**BEFORE THE PUBLIC UTILITY COMMISSION  
OF OREGON**

LC 73

2019 Integrated Resource Plan.

ORDER

*Figure 1: Mixed full clean action plan window resource additions*

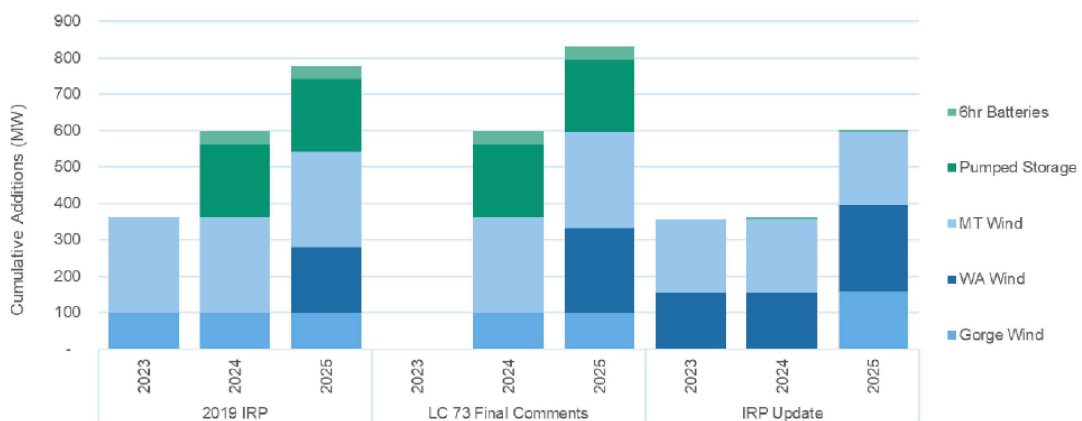
PGE's 2019 IRP Update decreases the amount of dispatchable capacity the Company plans to acquire in the action plan timeframe, as shown in Figure 1, which is reproduced from IRP Update page 52:

PGE's IRP Update suggests that the Douglas PPA caused the change shown in Figure 1. However, PGE's June 2020 supplemental testimony in Docket No UE 377, the 2021

power cost update docket, describes the Douglas PPA as providing approximately 100-160 MW of capacity.<sup>13</sup> This confirms to Staff that the Douglas PPA does not provide enough capacity on its own to replace all of the 595 MW of dispatchable capacity selected through 2025 from PGE’s 2019 IRP preferred portfolio, which is reproduced from IRP page 215 below:

In order to identify the extent to which the IRP model selection of near-term renewables is dependent on assumptions about increasing market prices and imminent PTC expiration, PGE should work with Staff to develop sensitivities for analysis in the RFP. PGE should use these sensitivities to inform its final shortlist and its choice between dispatchable, non-emitting capacity and near-term renewable resources for meeting its capacity needs. Staff requests that PGE collaborate with Staff in developing low market price and PTC extension sensitivities and reporting for inclusion with the Final Shortlist in the upcoming RFP.<sup>14</sup>

*Figure 2: PTC extension effect on cumulative renewable additions in the preferred portfolio reference case*

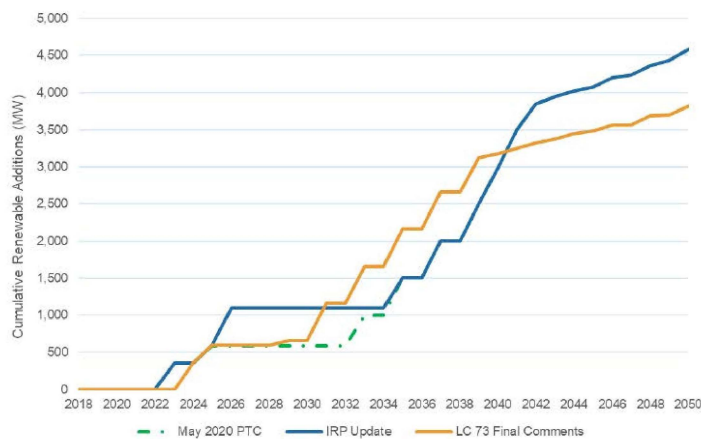
The 2019 IRP Update preferred portfolio has less near-term dispatchable capacity than the 2019 IRP preferred portfolio, and includes additional renewables in 2023 and 2026. This appears to be a result of the 2020 PTC extension, as shown in the figure below reproduced from IRP Update page 53, which shows additional renewable additions before the extended 2026 PTC expiration:

Staff finds that PGE's IRP Update moves away from the dispatchable capacity resources in the 2019 IRP Preferred Portfolio and instead acquires slightly more non-dispatchable renewable resources through 2025, followed by 500 MW of additional non-dispatchable renewables in 2026. The 2026 addition is attributable to the most recent PTC extension, and may also be influenced by the forecast of continually increasing market prices throughout the planning timeframe. A high market price forecast tends to support the economics of procuring resources and going long to the market as a net energy seller.
